BRUNSWICK STEAM ELECTRIC PLANT UNIT 2

AMENDMENT TO FACILITY OPERATING LICENSE

Amendment No. 10  
License No. DPR-62

SAFETY EVALUATION BY THE OFFICE OF NUCLEAR REACTOR REGULATION  
SUPPORTING AMENDMENT NO. 16 TO FACILITY OPERATING LICENSE NO. DPR-62

Figure 1. Plug Installed in Core Plate

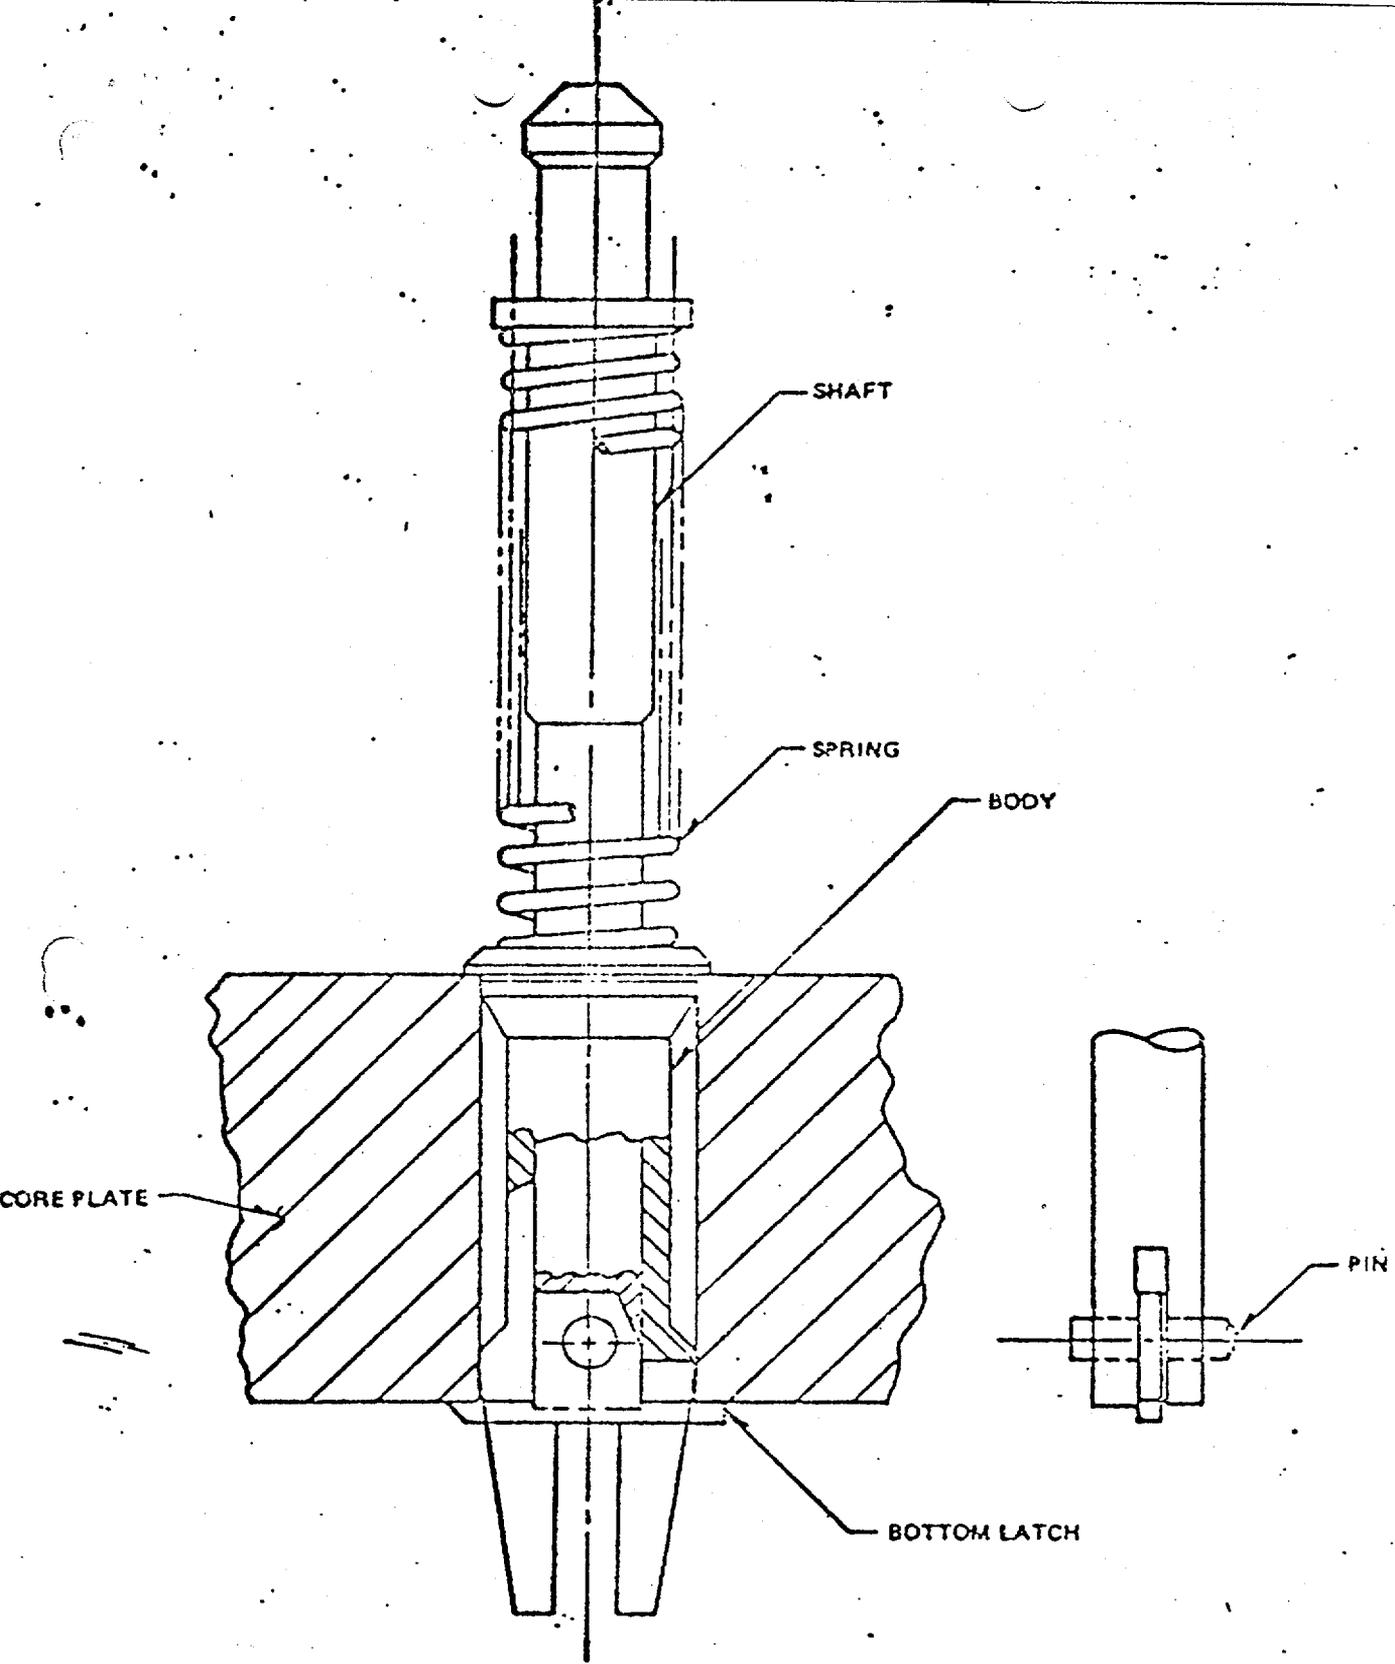
The plug consists of five basic parts, as shown in Figure 1. Identical plugs have previously been installed at Vermont Yankee, Pilgrim, Cooper, Hatch and Duane Arnold. The body provides a means of guiding the device into the bypass flow holes as well as a shoulder to support the plug and form a seal against water flow. The shaft extends through the body. A knob is provided at the top of the shaft to provide a means of grabbing the plug during installation and extraction. At the bottom, the latch is attached to the shaft by a pin. The latch is free to rotate during installation. The spring acts against the body and shaft during normal operation to provide the force necessary to offset the pressure differential acting on the body.

During installation, the plug has its latch rotated 90 degrees from its installed position and is withdrawn and locked in the body. The shaft is gripped by the installation tool, and the plug is inserted into the bypass flow holes. The body engages the rim of the hole. The shaft is pushed to its full extension, thus lowering and unlocking the latch below the underside of the core plate. The latch then rotates 90 degrees and bears on the bottom of the core plate. After insertion, the plug is pulled with about 30-pound force to test the placement.

The plug can be removed by gripping the top of the shaft with an extracting tool and applying a force of about 500 pounds. The latch's legs will be plastically deformed and the entire plug withdrawn. The plugs previously installed at Vermont Yankee were removed with no abnormalities or loose pieces reported. The force required for removal varied from 500 to 1300 pounds.

Based on a review of the design, the installation methods, and the previously successful operating experience at Vermont Yankee, Pilgrim, Hatch, and Duane Arnold, we conclude that the plugs can be installed without damage to core components, that they will not fail so as to result in loose parts in the core or result in unplugging of the bypass flow holes, and that they can be removed, if necessary, without damage to core components. Thus, the modification is reversible.

Accordingly, we conclude that the installation of the plugs is acceptable. Operation with plugged bypass holes is still under review and will be the subject of a separate licensing action.
